ADDENDUM NO 4 2023-R BETHLEHEM COMMUNITY PARK IMPROVEMENTS

Addendum to Include Specifications from Addendum #3 reflected in Plans

BETHLEHEM PARK COLUMBIA COUNTY, FLORIDA

S3

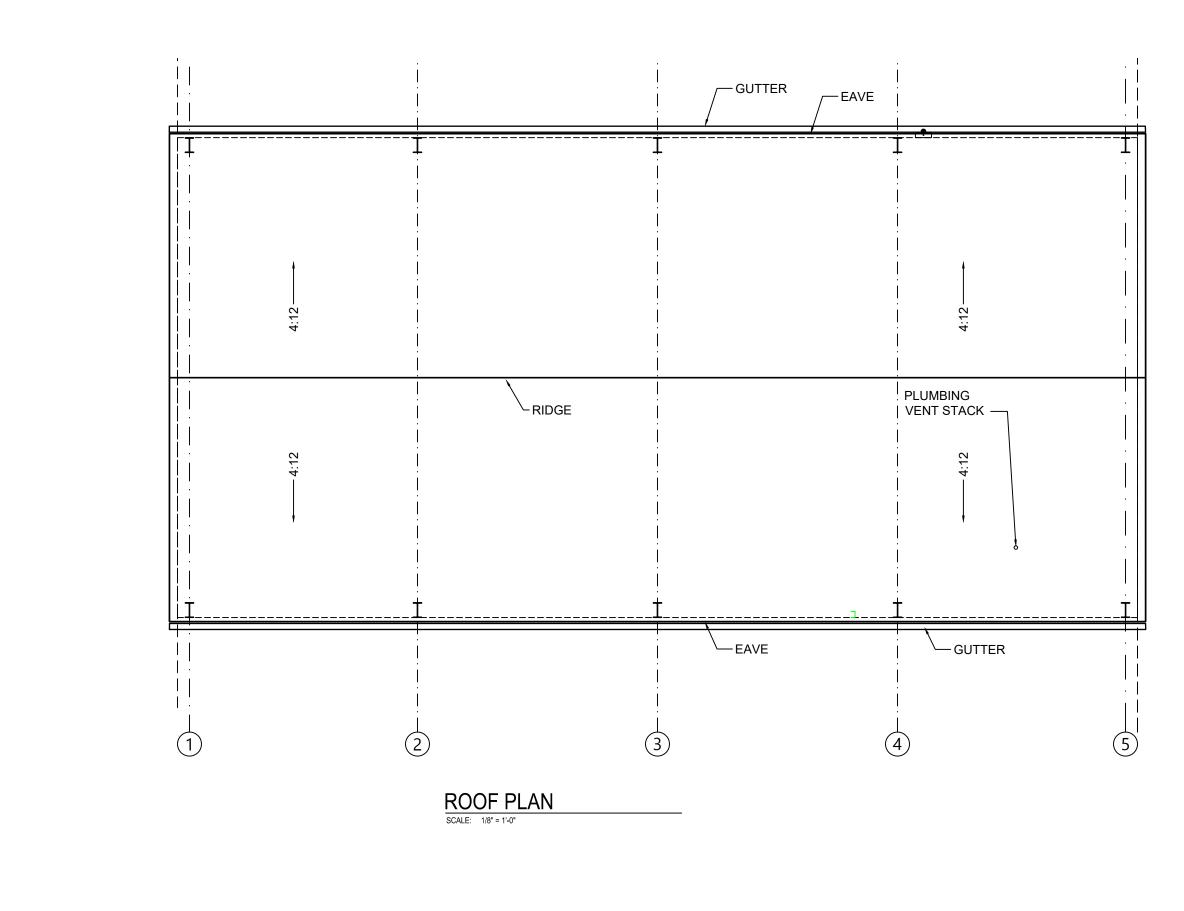
12/05/2023 REMOVED PLYWOOD ON WALL AND ADDED INTERIOR STUD WALL

MECHANICAL PLAN
BETHLEHEM PARK ASSEMBLY BUILDING
COLUMBIA COUNTY, FLORIDA

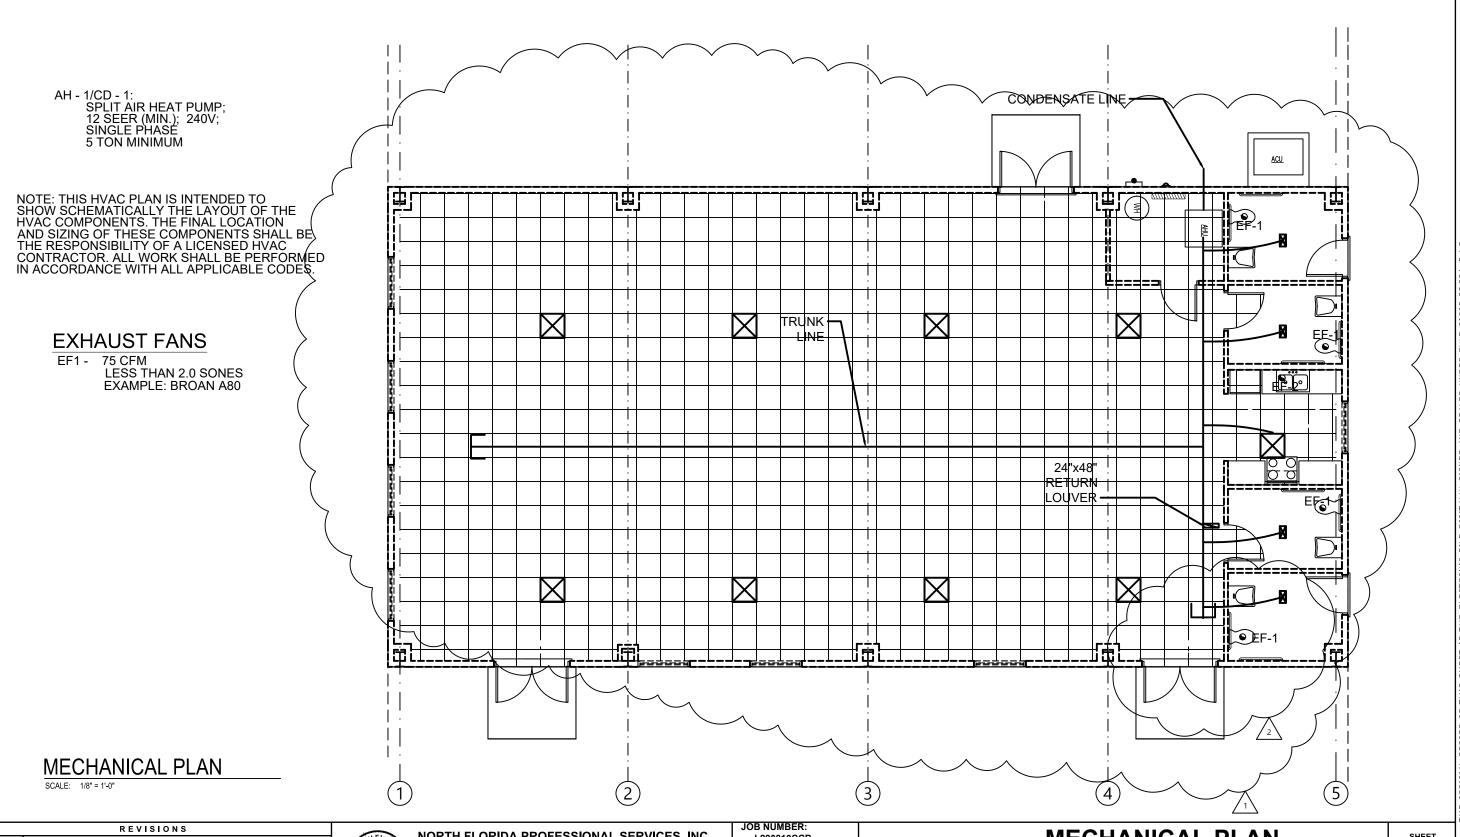
12/05/2023 ADDED REFLECTED CEILING 12/19/2023 REMOVED CONDENSATE LINE AND AH-1 CALL OUT NFPS OF STORY

LIGHTING PLAN BETHLEHEM PARK ASSEMBLY BUILDING COLUMBIA COUNTY, FLORIDA

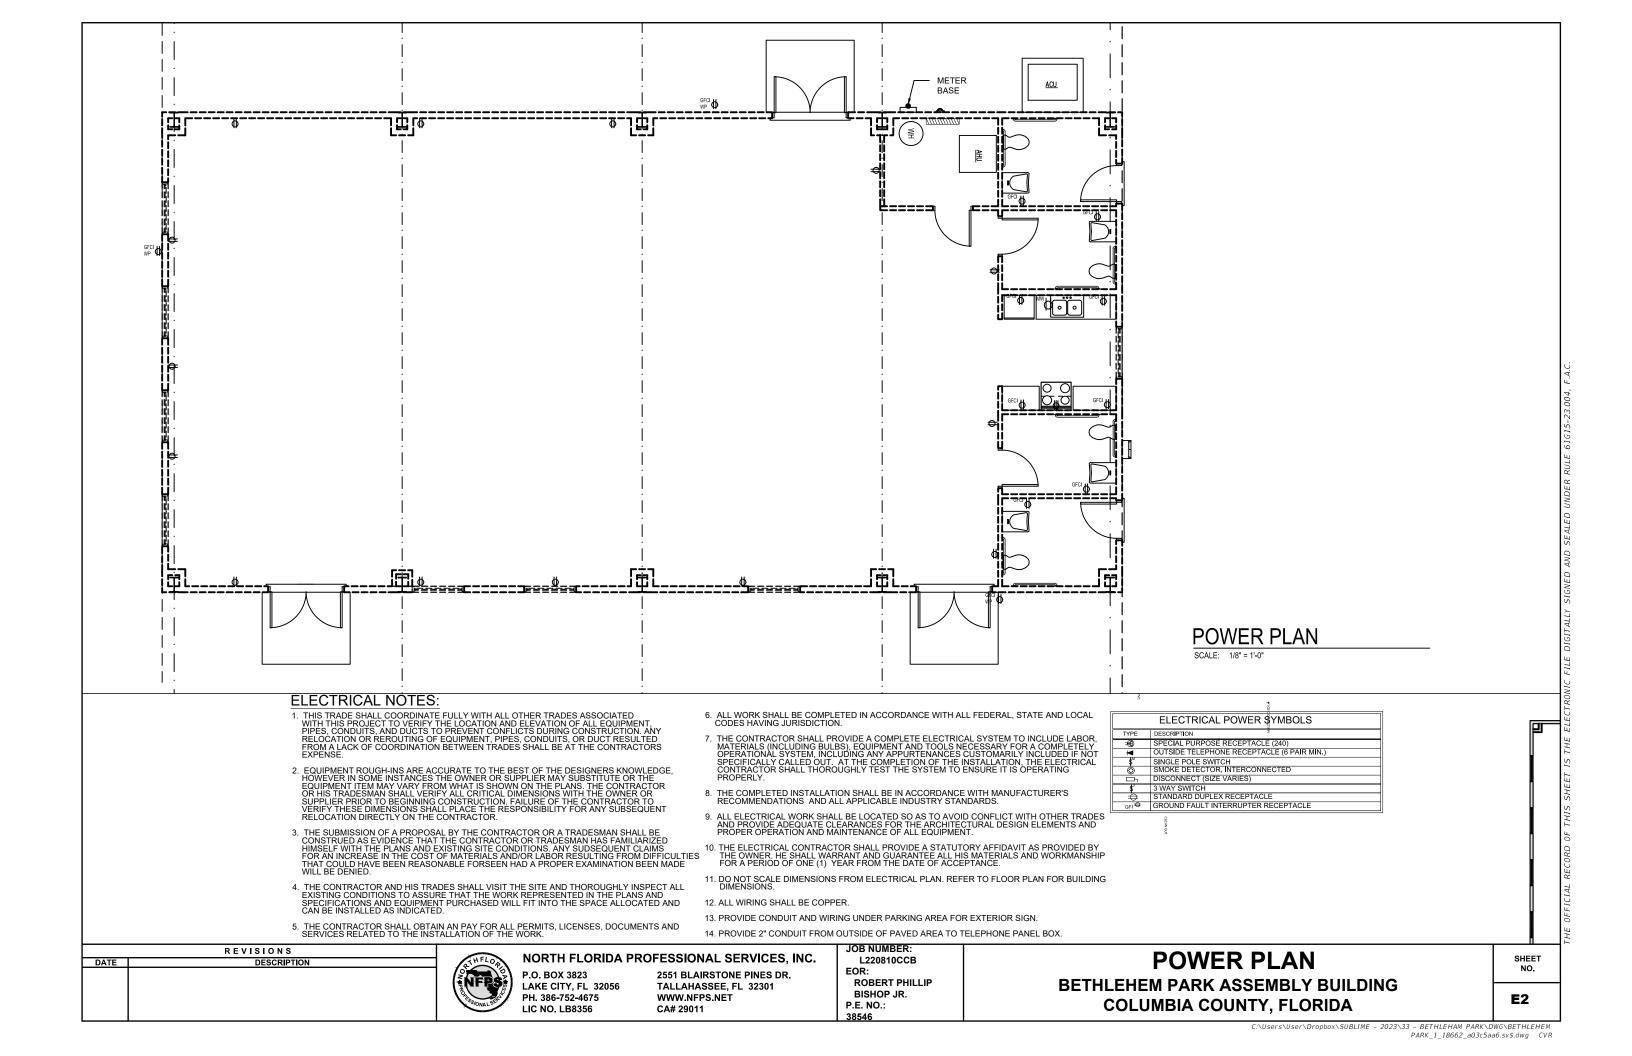
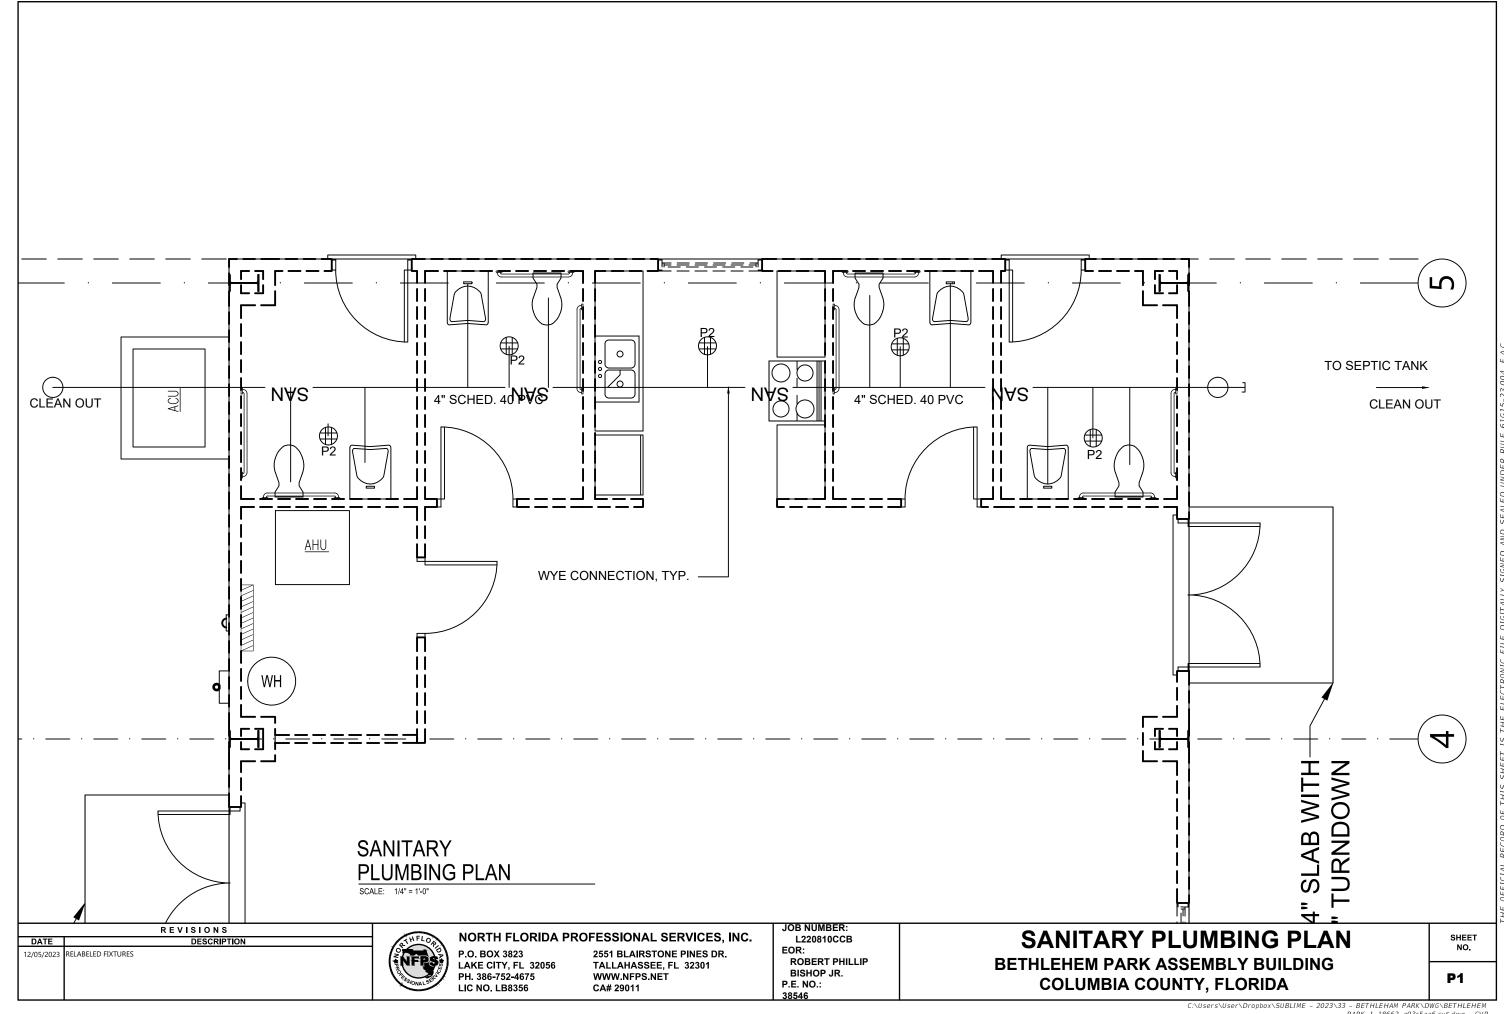
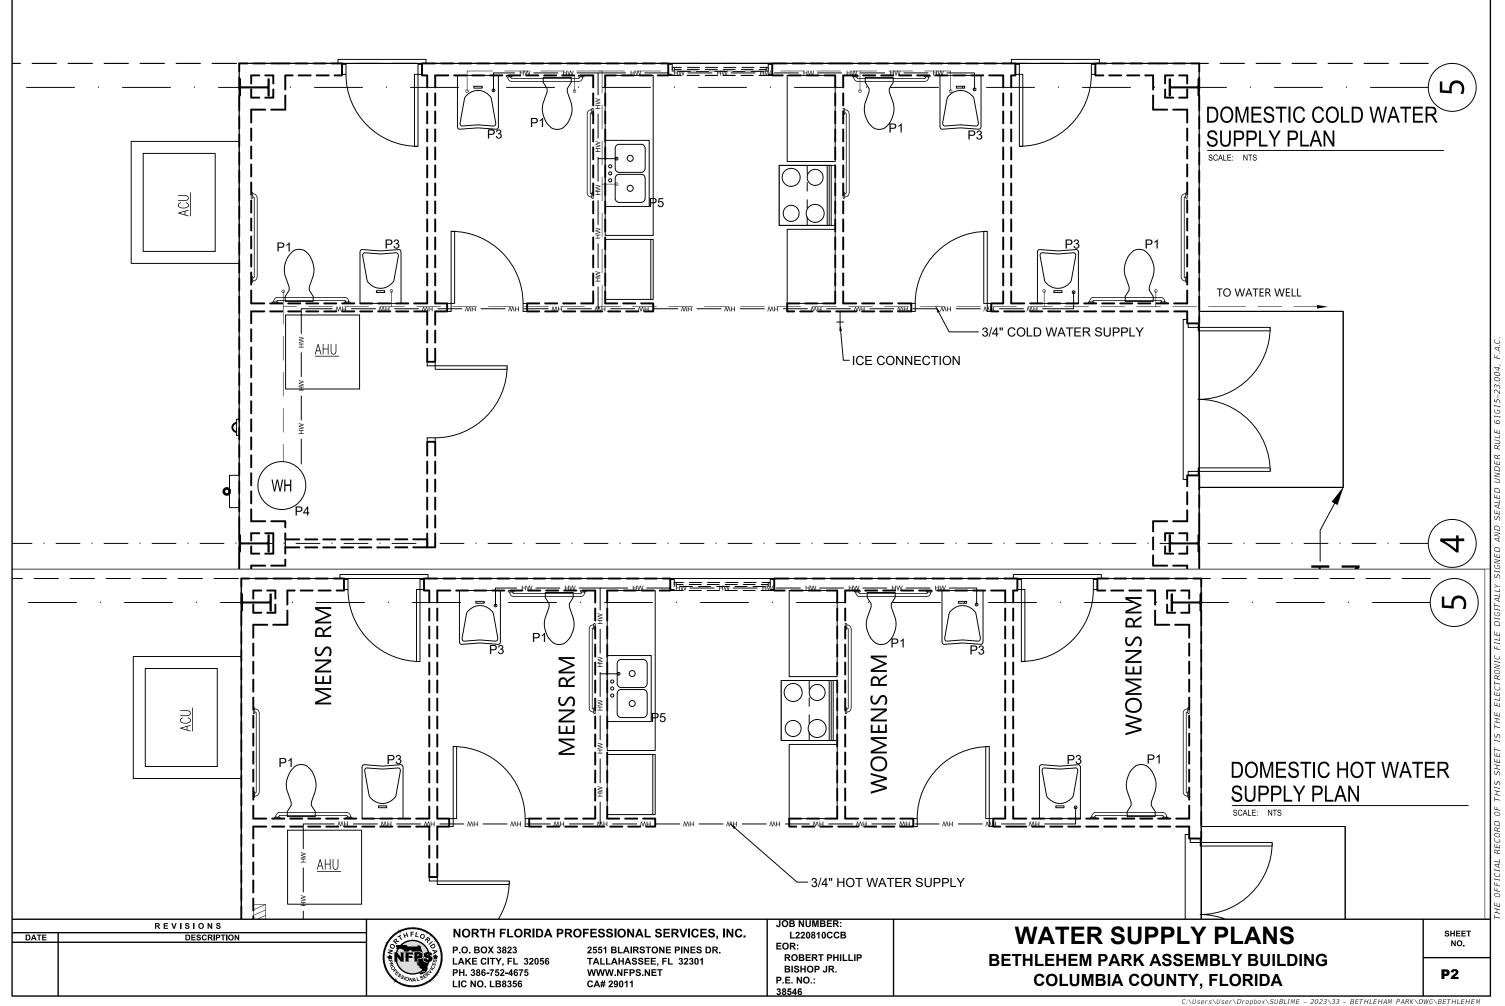
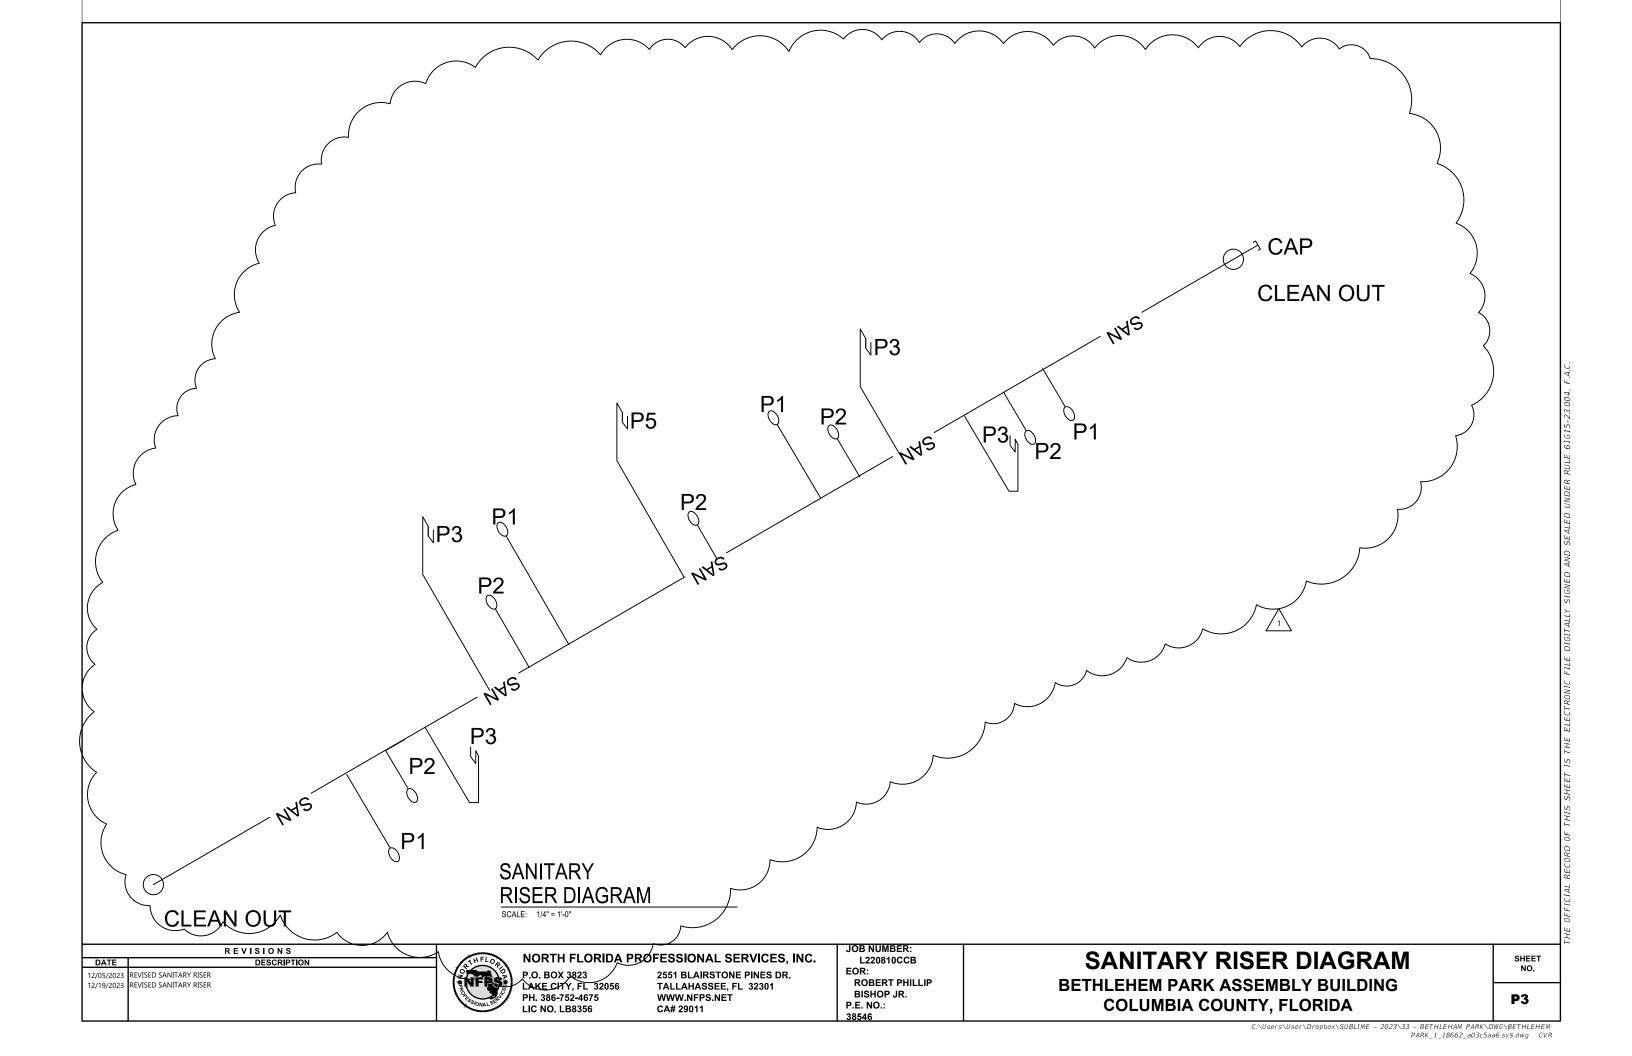
DESCRIPTION 12/05/2023 ADDED REFLECTED CEILINGAND CHANGED AMPS ON METER BASE
